Service Bulletin

Bulletin No.: 23-NA-209

Subject: Oil Can and/or Pop Noise from Roof Area During Car Wash

Brand:	Model:	Model Year:		VIN:		Engine:	Transmission:
		from	to	from	to		
Chevrolet	Colorado	2023	2025	-	-	All	All
GMC	Canyon

6484170

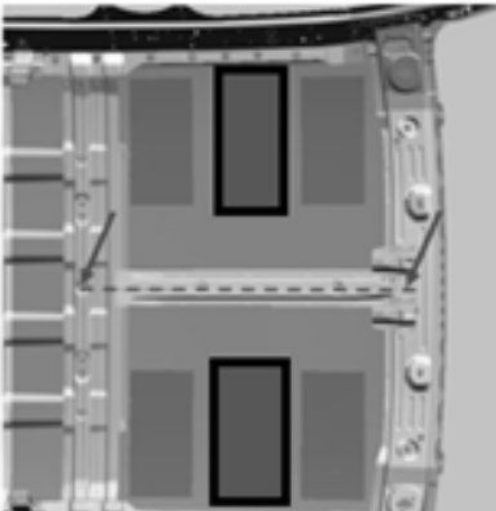
2. If the vehicle has already had the 5 stiffening panels installed to the underside of the roof panel in the RED locations in the illustration above, proceed to step 4. It is not necessary to remove any of the stiffening panels that have been previously installed before installing the roof bow.

3. Once the headliner is dropped (but not removed) apply the 2 stiffening panels to the underside of the roof panel in the RED locations in the illustration above.

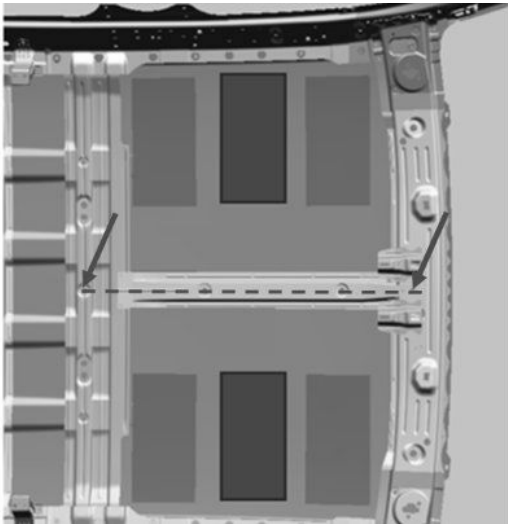
4. Pre-Drill Roof Bow (6.7mm (17/64) for the rivet in the areas (x5) shown in the above graphics.

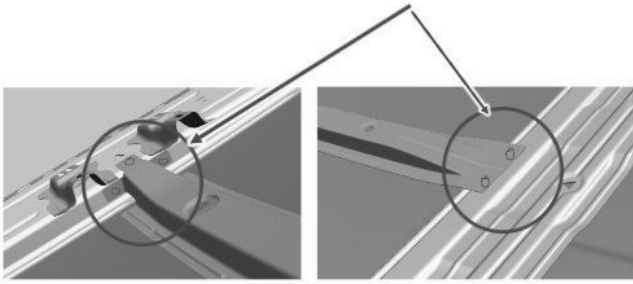
5. Using magnets to hold the roof bow in the proper position (Align the center line of the roof bow to the center line of the triangles in roof bars as shown in the above image).
Drill holes in the underside roof structure using the pre-drilled roof bow as a template- and using depth control device on bit.
6. Remove the roof bow.

6805508

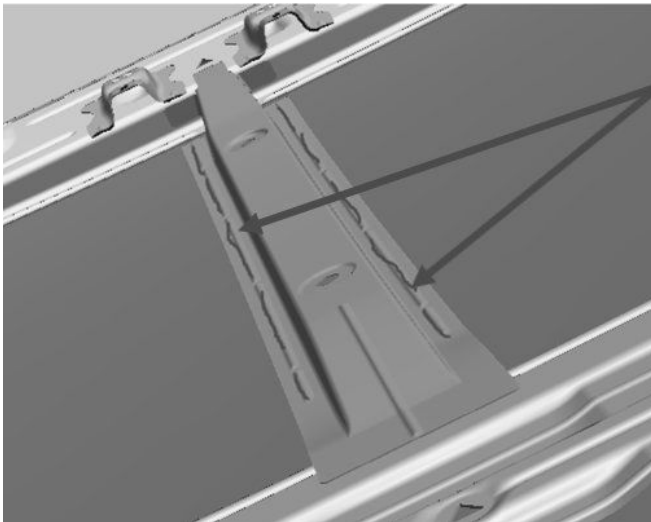
7. Apply crash durable structural adhesive Fusor 2098 or equivalent as called out in the graphic with a 3mm width of wet out along both ends.

8. Apply panel vibration control material - anti-flutter SEM #39977 or equivalent along the length of the bow as called out in the above graphic.
